**Číslo: DCA/750XL/3A**

### **DCA/750XL/3A      Wiring Loom Protective Sleeve – Inspection and Installation**

PACSB / XL / 009 Issue 2

### INSPECTION – WIRING LOOM PROTECTIVE SLEEVE

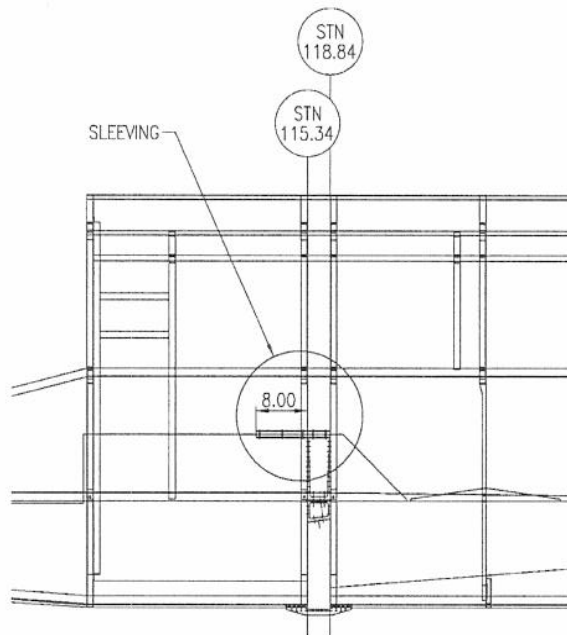
| C. | DESCRIPTION        | Two pieces of protective sleeving should be present, wrapped around the main loom on the RHS of the aircraft adjacent to the frames at stations 115.34" and 118.84". This inspection is to determine that the sleeving is actually present. |

1. Remove the interior lining on the RHS of the fuselage above the wing spar. (Refer MM Ch 25, 25-10-00, page 401.)
2. Examine the loom as it passes the fuel vent lines adjacent to stations 115.34" and 118.84". There should be clearly visible, dark green or clear plastic sleeve wire-tied around the loom at these points. Refer illustration.

1. If sleeving is present, the longer sleeve will extend 8" forward of station 115.34", and the shorter (3.5") sleeve should fill the gap between the frames. If all is correct, reinstall the linings.
2. If missing, order part number SLE2-1-080S (8") and/or SLE2-1-035S sleeves from PAC spares. To install, position as indicated on the drawing excerpt, wrap around the loom and position as illustrated above. Wire-tie the sleeves as illustrated.
